February 14, 2012

Draft Environmental Impact Report
Southern California International Gateway (SCIG) Project

Figure 1
Simplified Air Quality Dispersion Modeling Process Flowchart

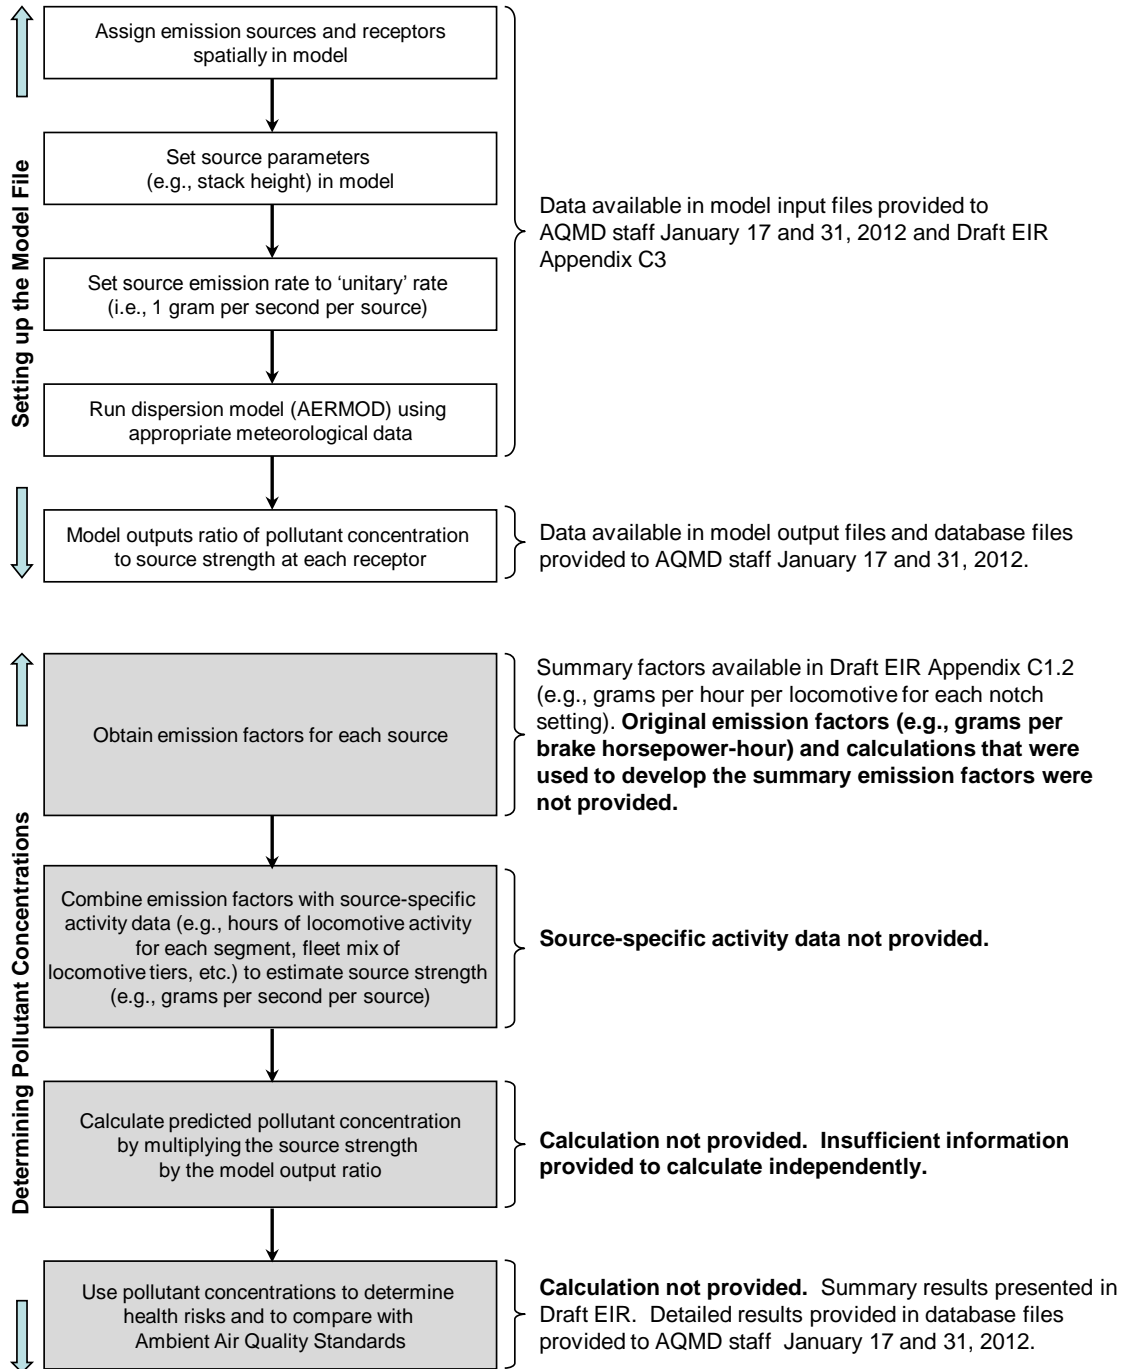
Figure 1 below presents a simplified flow chart describing the steps that are followed to convert emission factors into predicted pollutant concentrations using a dispersion model like AERMOD. As can be seen in the figure, critical data was not provided to AQMD staff or to the public. This data is necessary to confirm the validity of the results of the dispersion modeling analysis. A

Note: Shading indicates information not provided that is critical to calculating pollutant concentrations
